CERTIFICATE OF APPROPRIATENESS

Property: 642 Columbia Street, Lot 23, Block 281, Houston Heights Subdivision. The property includes a noncontributing 2,086 square foot, one-story wood frame brick clad single family residence and one-story detached garage situated on a 6,600 square foot (50' x 132') interior lot.

Proposal: New Construction – (Revision) Construct a two-story 3,798 square foot single family residence. The proposed residence will be 36' wide and 72' deep (including porches), have a ridge height of 32'-8" and eave height of 22'-6", but portions of the residence will be articulated in a different manor than previously approved.

WEST ELEVATION – FRONT FACING COLUMBIA STREET

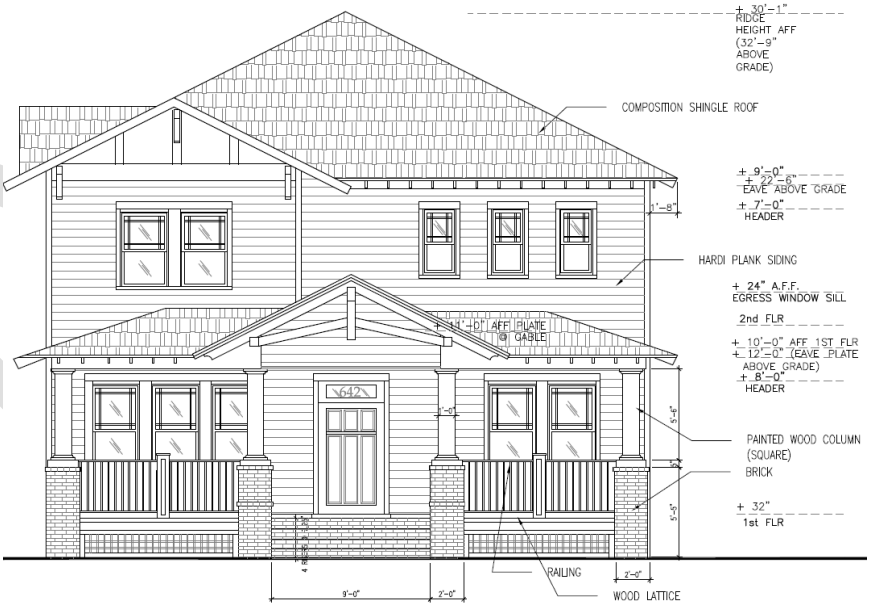
Recommendation: **Partial Approval:**

- The decorative double-hung windows are to be 1-over-1
- All other decorative windows are to be single-lite
- The steps are to be constructed from wood or a composite material, including concrete
- The decorative porch railing posts are to be simplified
- The brick porch posts should be wood with a simple design

Front Elevation: (West) 12-17-2014: The proposed three bay residence will have a full width front porch with the stairs opening onto the central bay. The metal standing seam porch roof will be supported by four brick piers topped by square wood columns. Central bay of the porch roof will feature a front facing gable. The northern bay consists of a pair of windows on the first and second floors. The western bay consists of a group of three windows on the first and second floor and is topped by a decorative gable. The central bay consists of the front door on the first floor and a fixed window on the second floor. A main hipped roof tops the residence.

01-29-2015: In the proposed revisions, the first story will remain unchanged with the exception of a slight expansion and porch roof alterations. The porch roof will now be hipped at the ends and include an altered front gable feature. The second story window pattern will be altered. The projecting western bay will now consist of a pair of decorative windows. The centered square window above the porch gable will be removed and the pair of windows on the east will be replaced with three smaller individual windows. The roofline will also be altered, as a side gable will project to the north from the front gable. See drawings for more detail.

SOUTH SIDE ELEVATION

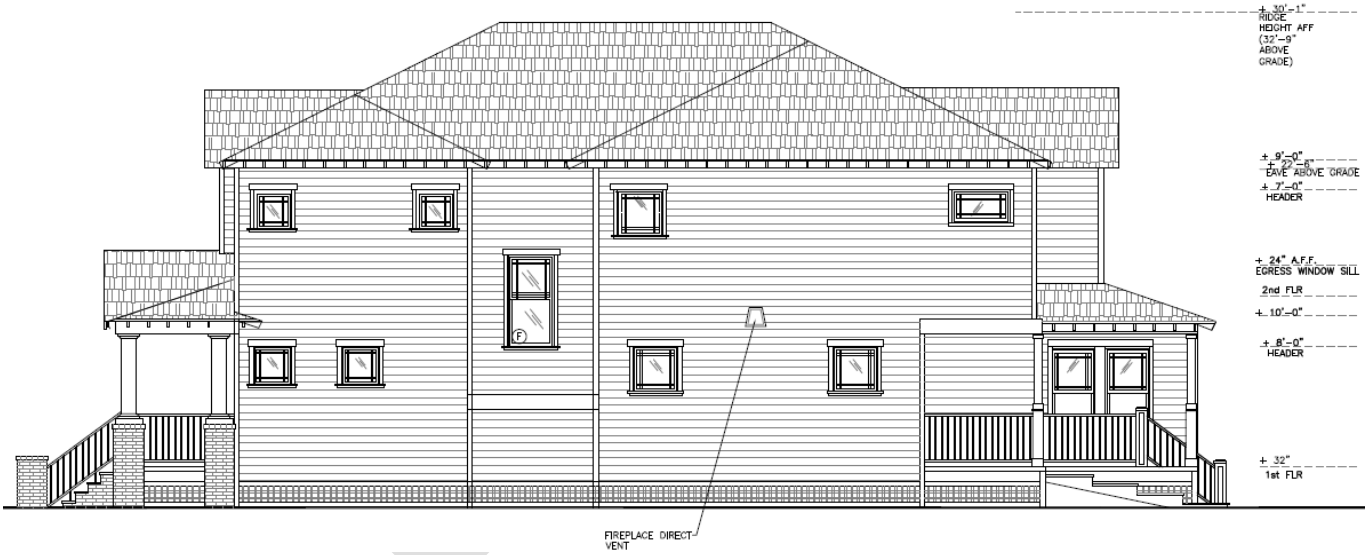
Side Elevation: (South) 12-17-2014: The proposed south elevation consists of the side profile of the front porch to the west. The first story of the proposed residence consists of four fixed windows and a pair of double hung windows. The second story consists of three fixed windows and a single double hung window. A single double hung window is located between the two floors. A porch is located at the rear.

01-29-2015: In the proposed revisions, the south elevation will be more articulated. The western portion will include two square fixed windows on both the first and second stories. To the east, an inset portion will include a single double hung window. The eastern portion will project out and include two square fixed windows on the first story and two fixed windows on the second story. A rear porch includes an additional pair of double hung windows. See drawings for more detail.

NORTH SIDE ELEVATION

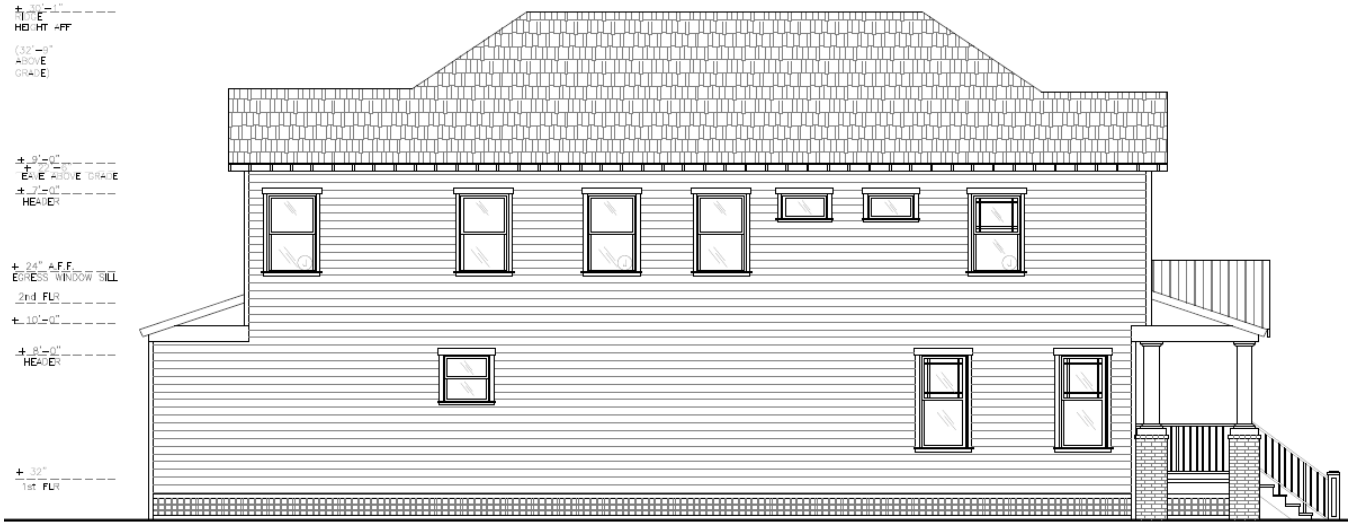
Side Elevation: (North) 12-17-2014: The proposed north elevation consists of the side profile of the front porch to the west. The first story of the proposed residence consists of three double hung windows. The second story consists of five double hung windows and two fixed windows.

01-29-2015: In the proposed revisions, the north elevation will include a projecting two story feature adjacent to the front porch with two double hung windows on the first story and no fenestration on the second. To the east, the first story will include a single double hung windows and a single rectangular fixed window. The second story will include a projecting window seat feature with a pair of double hung windows and topped by a gable. To the east of this projection, will be two additional double hung windows. See drawings for more detail.

WEST (REAR) ELEVATION

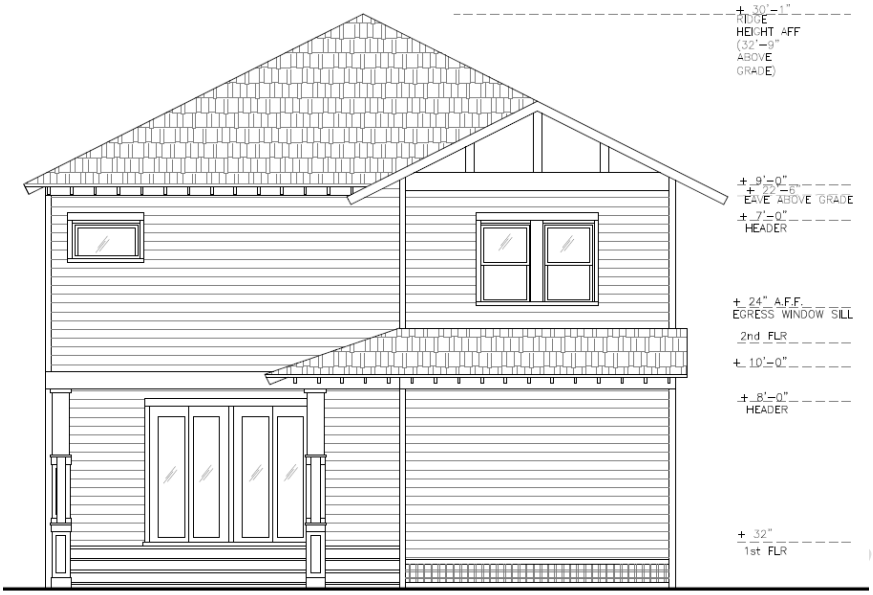
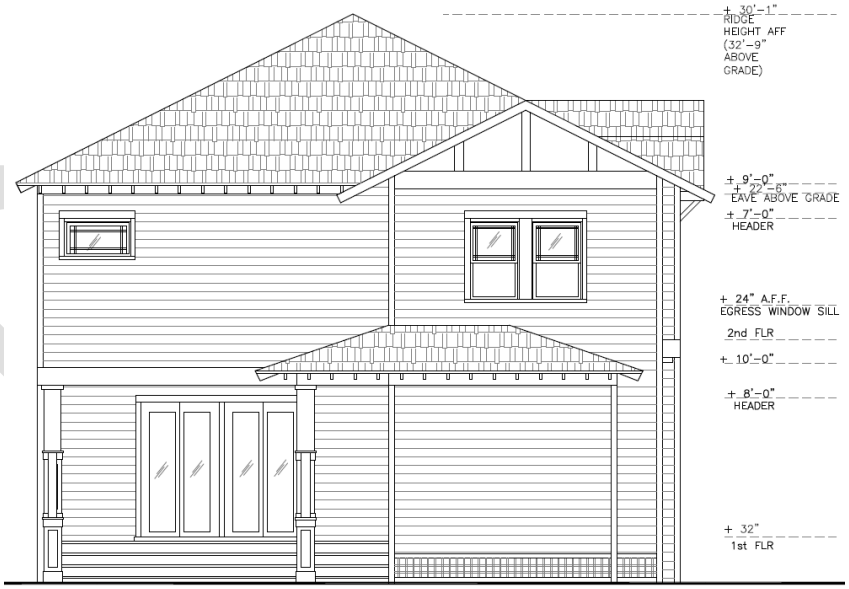
Rear Elevation: (East) 12-17-2014: The rear elevation of the residence will not visible from the public Right-of-Way.

01-29-2015: The proposed revisions to the rear elevation of the residence will not visible from the public Right-of-Way. See drawings for more detail.

SITE PLAN

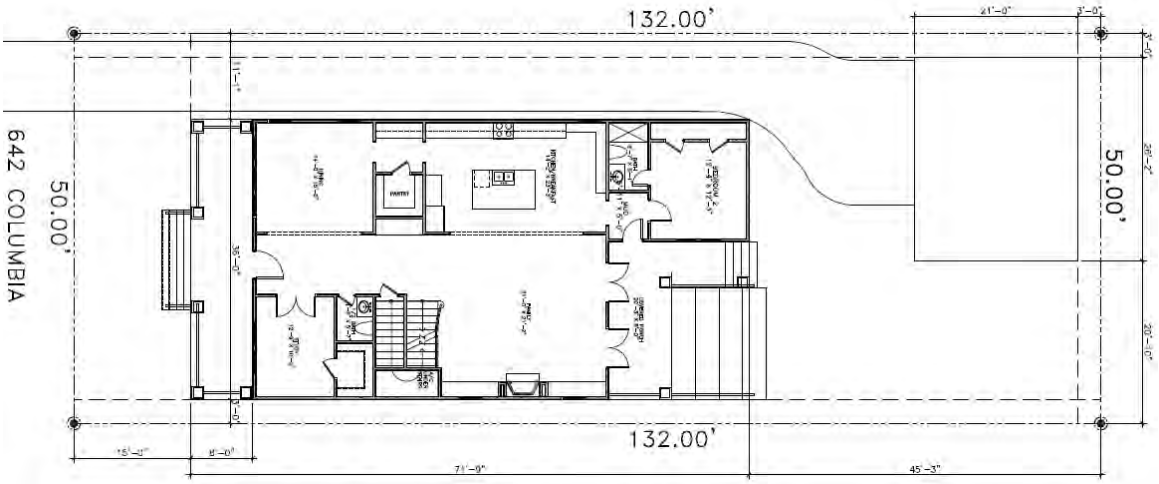
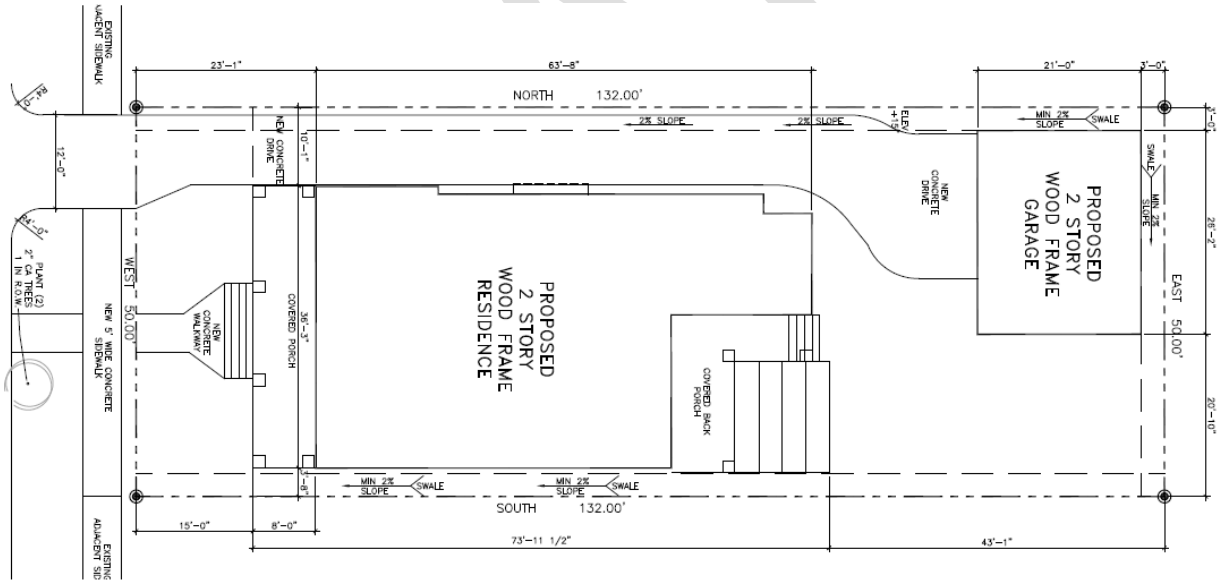
Setbacks: 12-17-2014: The proposed residence will have a west (front) setback will be 15'-0"; a south side setback of 3'-0"; a north side setback of 11'-1"; an east (rear) setback of 45'-3".

01-29-2015: The revised proposal will have a west (front) setback will be 15'-0" (unchanged); a south side setback of 3'-8"; a north side setback of 10'-1"; an east (rear) setback of 45'-3" (unchanged). See drawings for more detail.

ROOF PLAN

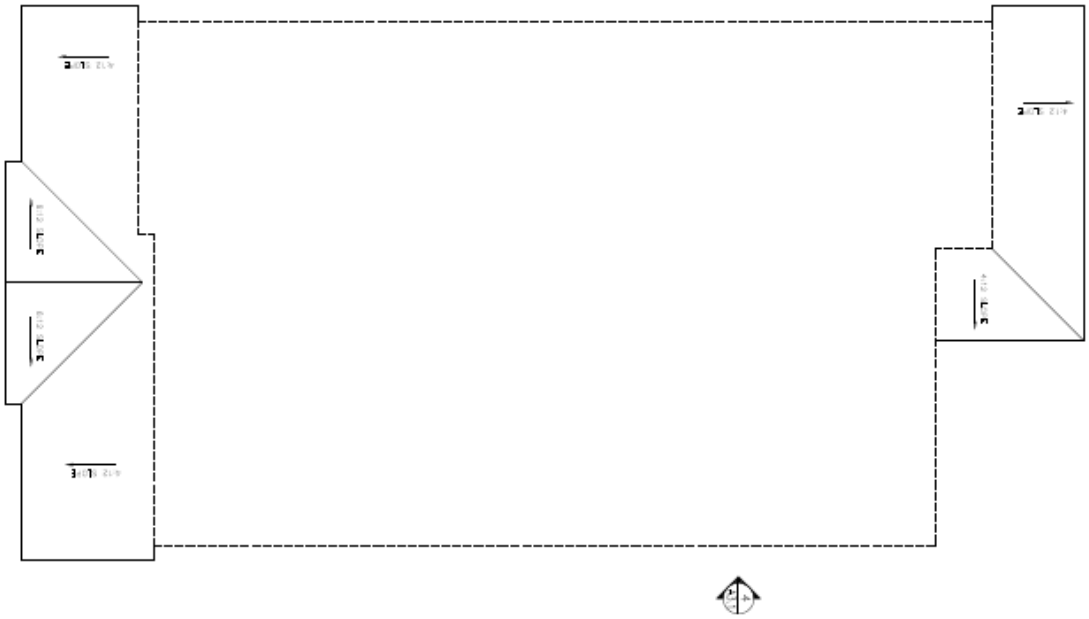
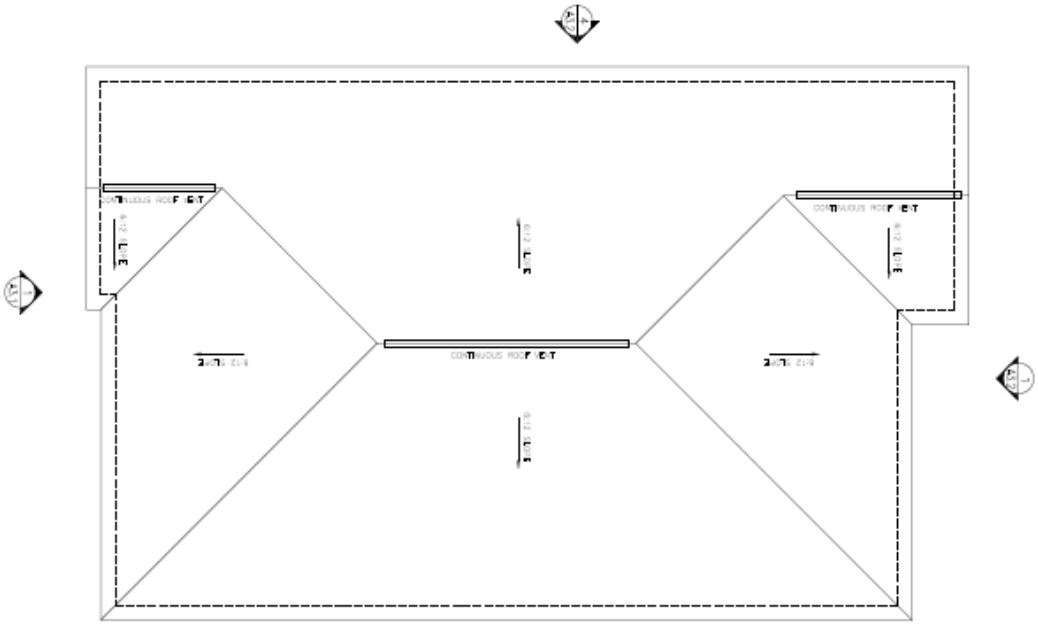
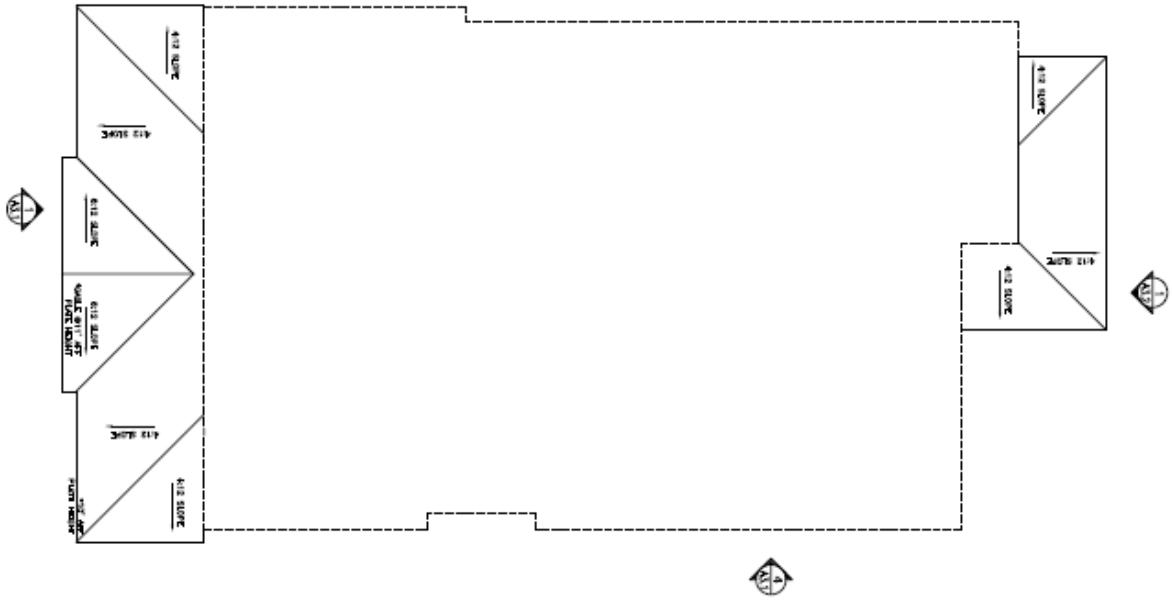
Roof: 12-17-2014: The proposed residence will have a composition shingle hipped main roof with decorative front gables and a standing seam metal porch roof. The proposed main roof will have a pitch of 6:12, an eave height of 22'-6, and open eaves. The porch roof will have a pitch of 4:12 and an eave height of 12'.

01-29-2015: In the revised proposal, the residence will have a composition shingle hipped main roof with decorative front gables and a composition shingle hipped porch roof. The proposed main roof will have a pitch of 6:12, an eave height of 22'-6, and open eaves. The eave overhang will be deepened to 1'-8". The porch roof will have a pitch of 4:12 and an eave height of 12'. A front gable will be installed above the porch steps. This gable will have a pitch of 6:12 and feature decorative brackets. See drawings and roof plan for more detail.
